## ADDENDUM NO. 04

<b>PROJECT:</b>	<b>Auburn Park Full Build-Out Montgomery County, VA Parks and Recreation</b>
<b>GNI Job No.:</b>	<b>2893.00</b>
<b>DATE:</b>	<b>Friday, March 15, 2024</b>

WALL SECTIONS -  
RESTROOM BUILDING

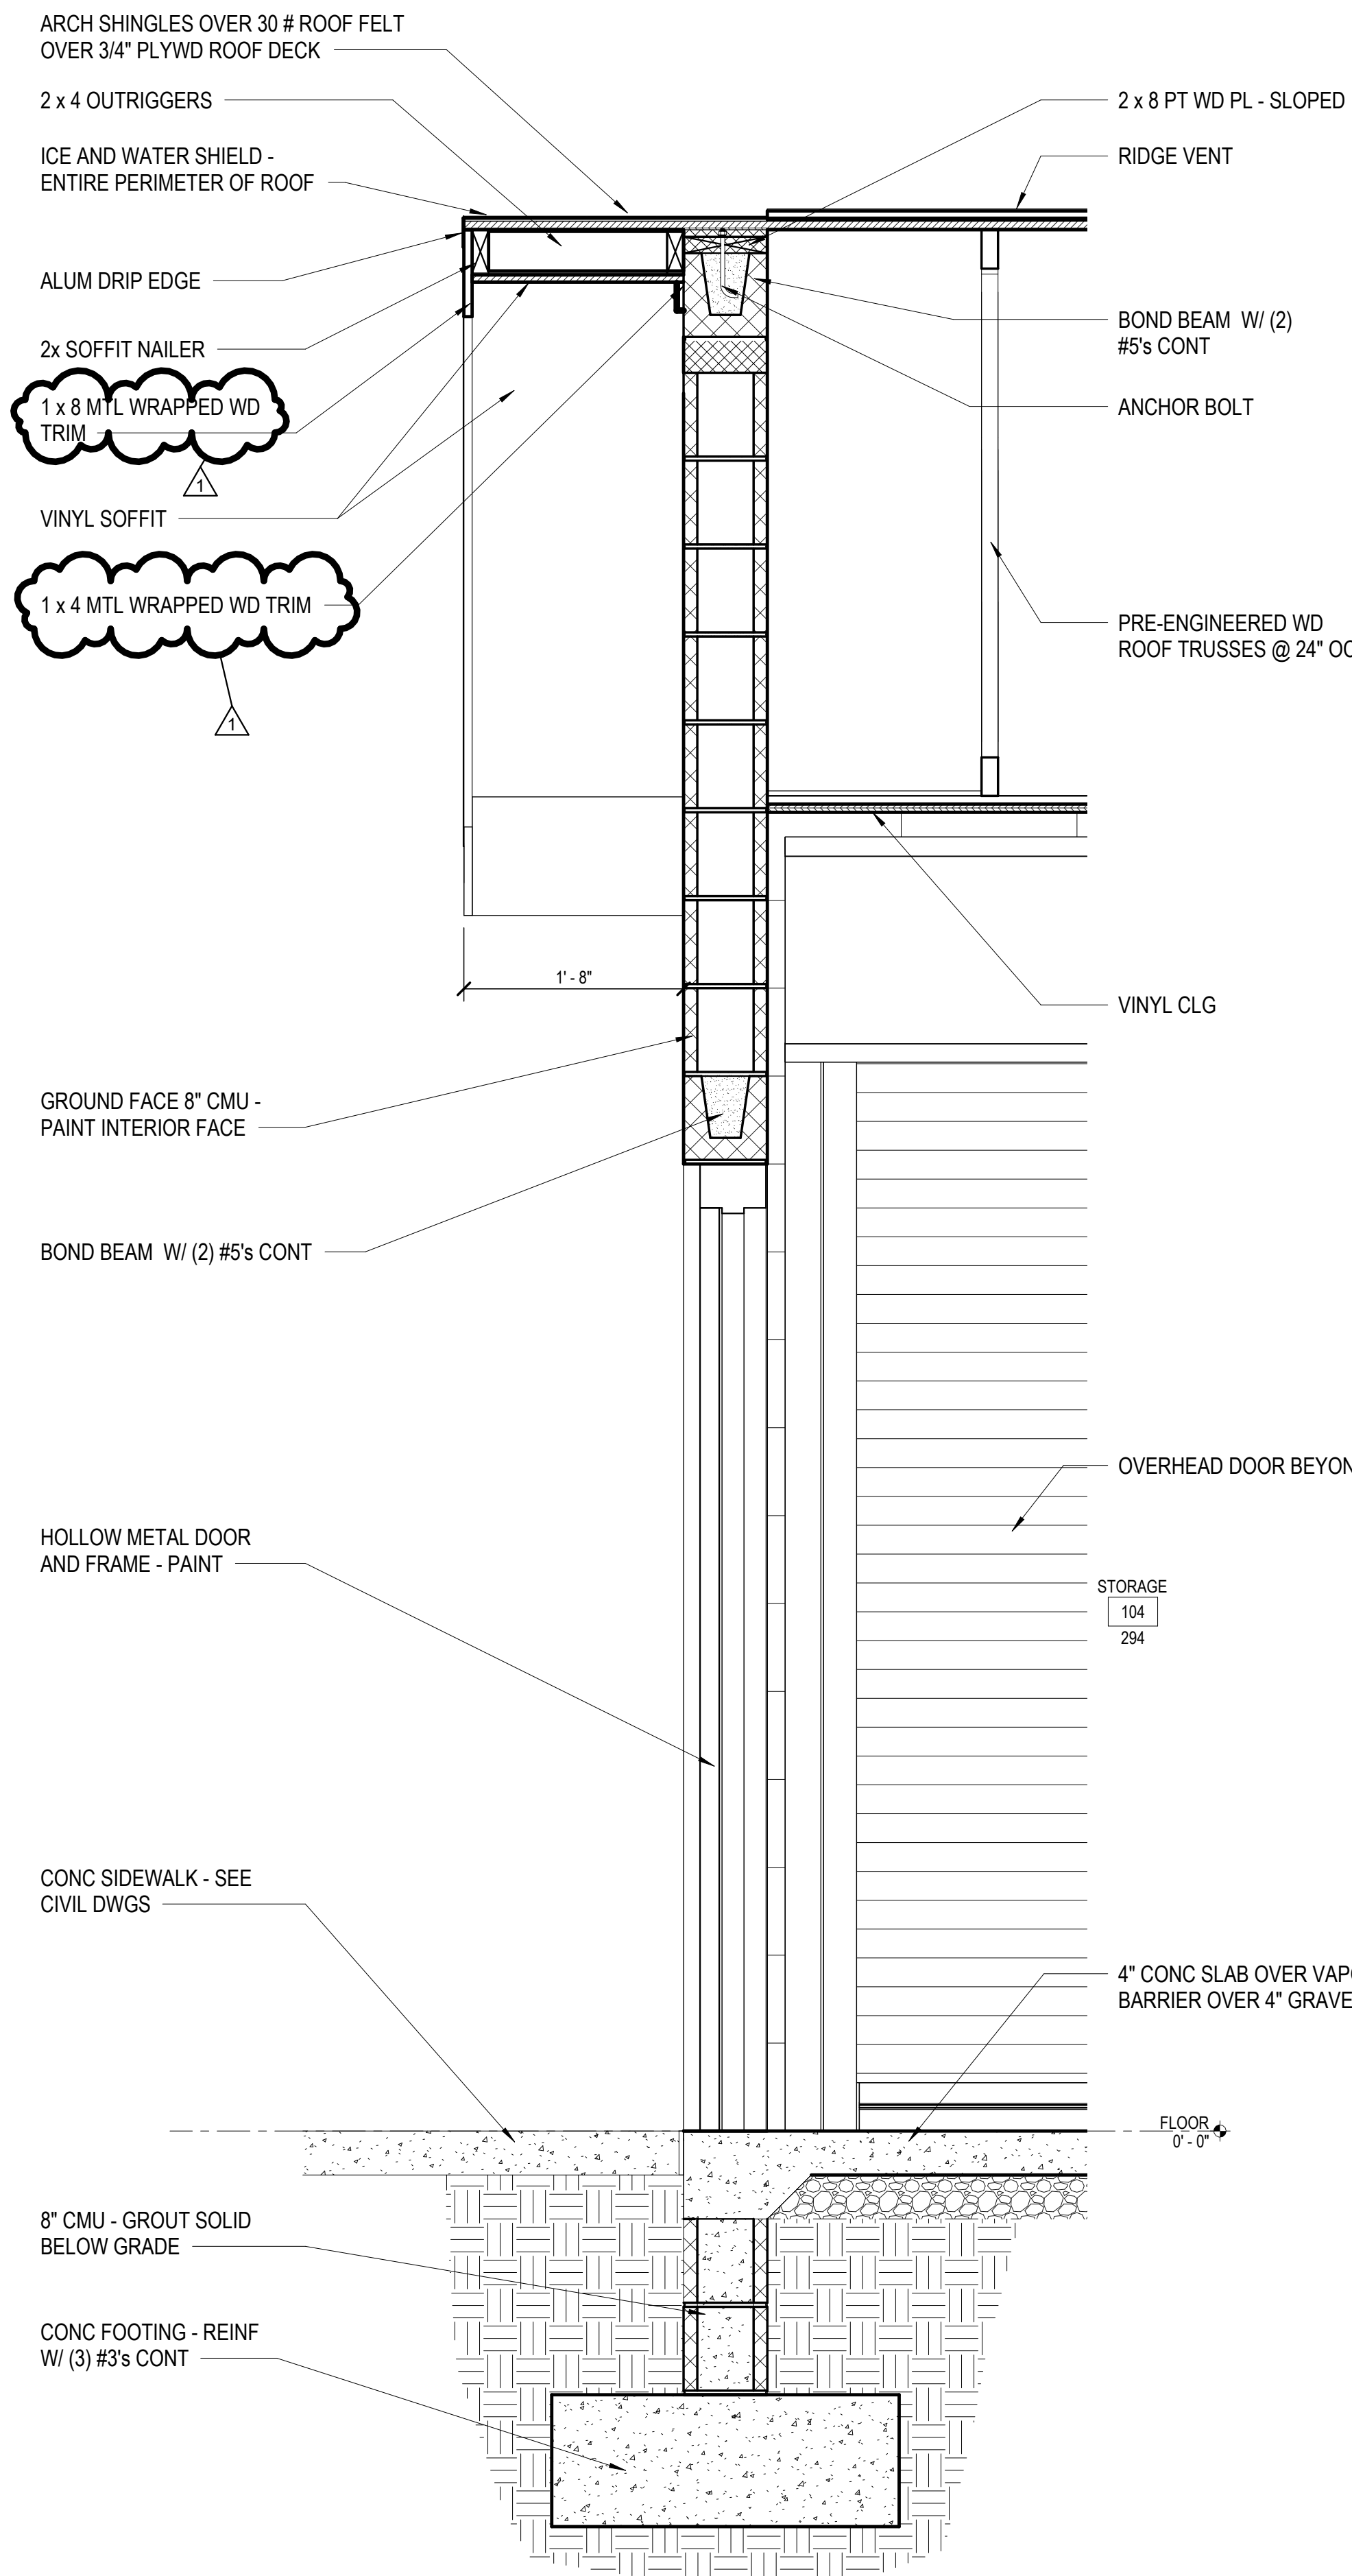
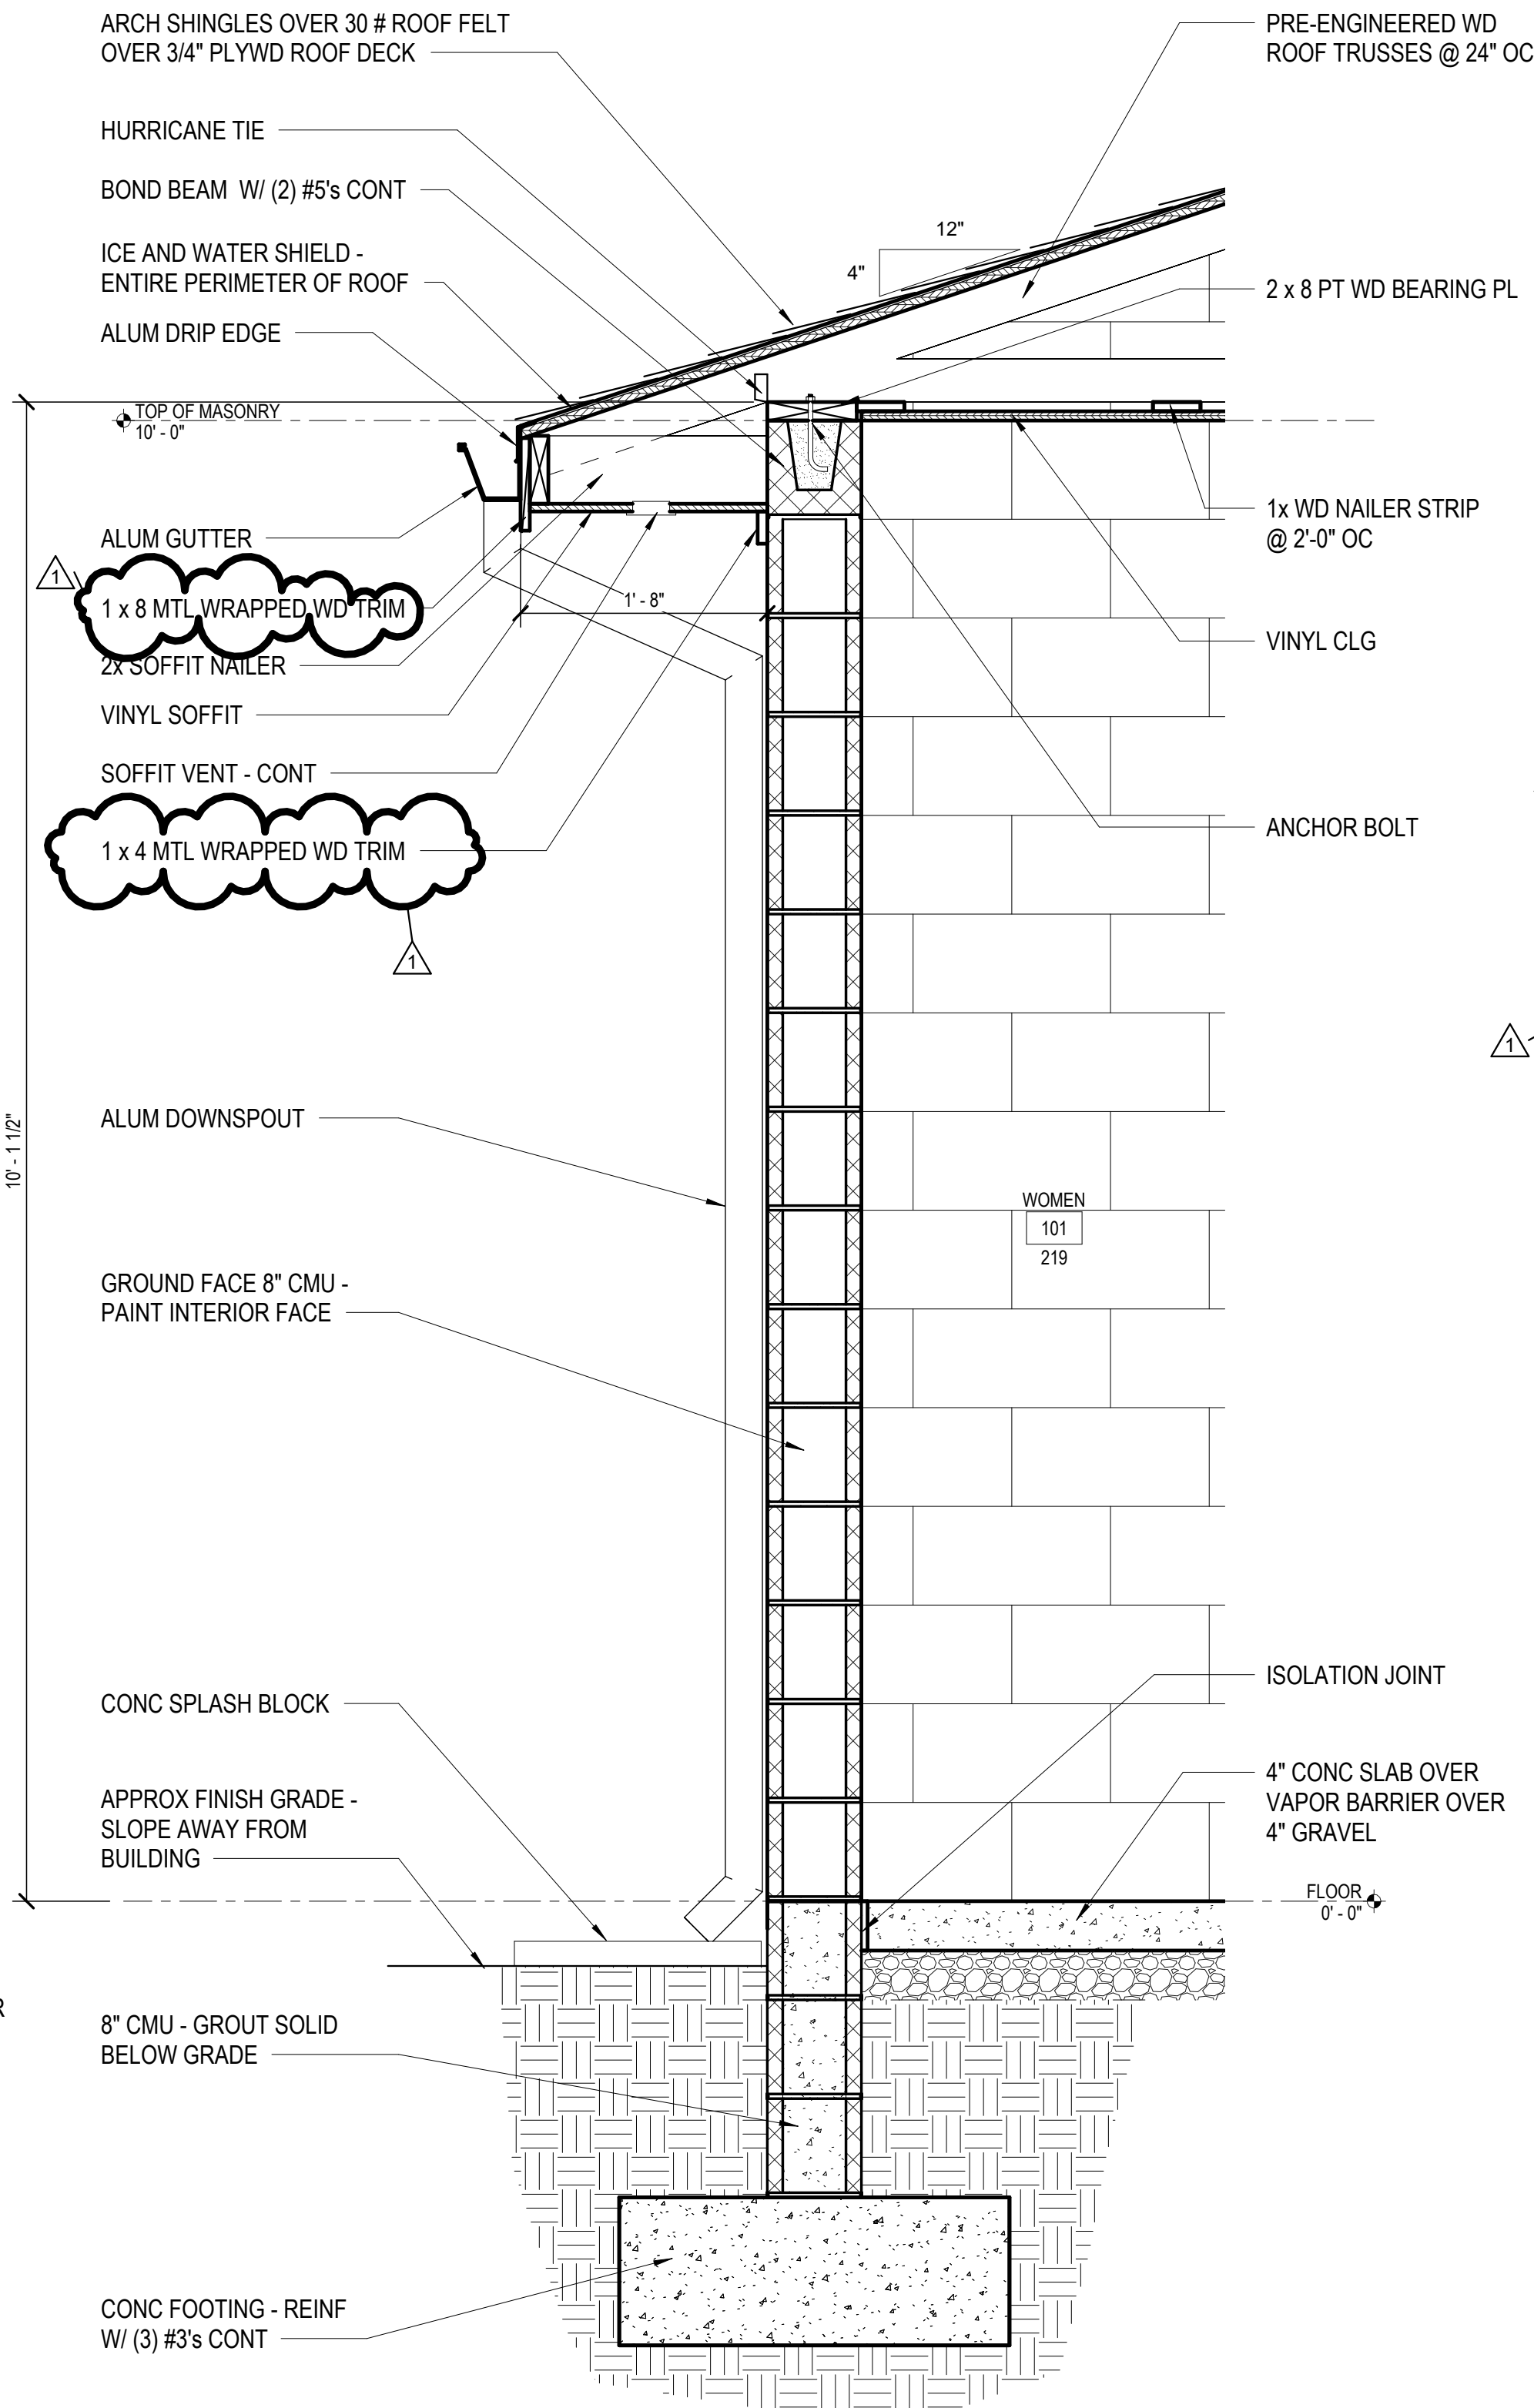
**REVISE** Labels calling for “1 x 8 PVC FASCIA” on all typical wall sections on this sheet to read as follows:

“1 x 8 WD FASCIA – METAL WRAPPED” as shown in attached revised Sheet A104 with revision date 3-14-24.

**REVISE** Labels calling for “PVC TRIM” on all typical wall sections on this sheet to read as follows:  
“1 X 4 MTL WRAPPED WD TRIM” as shown in attached revised Sheet A104 with revision date 3-14-24.
